Access Compliance Report

Public Rights-of-Way

(Curb Ramps)

Intersection ID: 52624	Main Street: CORMWELL_LN	Cross Street: CONTEMPORARY_PL	Location:	N
ADA ID: FD781DE68FE5	Ramp Type: Perp	Initial Pass/Fail: Fail	Overall Compliance: No	Severity Score: 12.5
Codes/Mitigation Info/Possible Solution		Field Measurements/Component Compliance

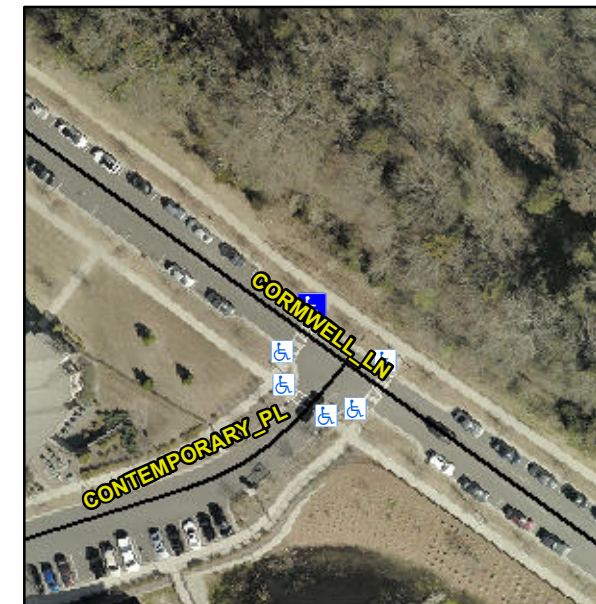
Not Found, R304.2.2

Compliance	Description	Data	Compliance	Description	Data
N/A	Ramp Length (in)	123.0	No	Ramp Slope (%)	10.4
Yes	Ramp Width (in)	60.0	Yes	Ramp XSlope (%)	0.6
N/A	Flare Type LT	N/A	N/A	Flare Type RT	N/A
N/A	Flare Slope LT (%)	N/A	N/A	Flare Slope RT (%)	N/A
N/A	Flare Traversable LT?	N/A	N/A	Flare Traversable RT?	N/A
N/A	Landing Length (in)	N/A	N/A	DWS Provided?	N/A
N/A	Landing Width (in)	N/A	N/A	DWS Contrast?	N/A
N/A	Landing Slope (%)	N/A	N/A	DWS Length (in)	N/A
N/A	Landing X Slope (%)	N/A	N/A	DWS Full Width?	N/A
N/A	Landing Curb? (Y/N)	N/A	N/A	DWS Offset (in)	N/A
N/A	Shared Landing?	N/A			
N/A	Gutter Ponding?	N/A	N/A	Gutter Slope (%)	N/A
N/A	Gutter Lip Ht (in)	N/A	N/A	Gutter X Slope (%)	N/A
N/A	Painted X Walk1?	Yes	N/A	Painted X Walk2?	N/A
	X Walk 1 Direction	To SW		X Walk 2 Direction	N/A
N/A	X Walk 1 Width (in)	62.5	N/A	X Walk 2 Width (in)	N/A
	X Walk 1 Slope (%)	5.4		X Walk 2 Slope (%)	N/A
	X Walk 1 X Slope (%)	0.1		X Walk 2 X Slope (%)	N/A

Remove & Replace Entire Ramp.
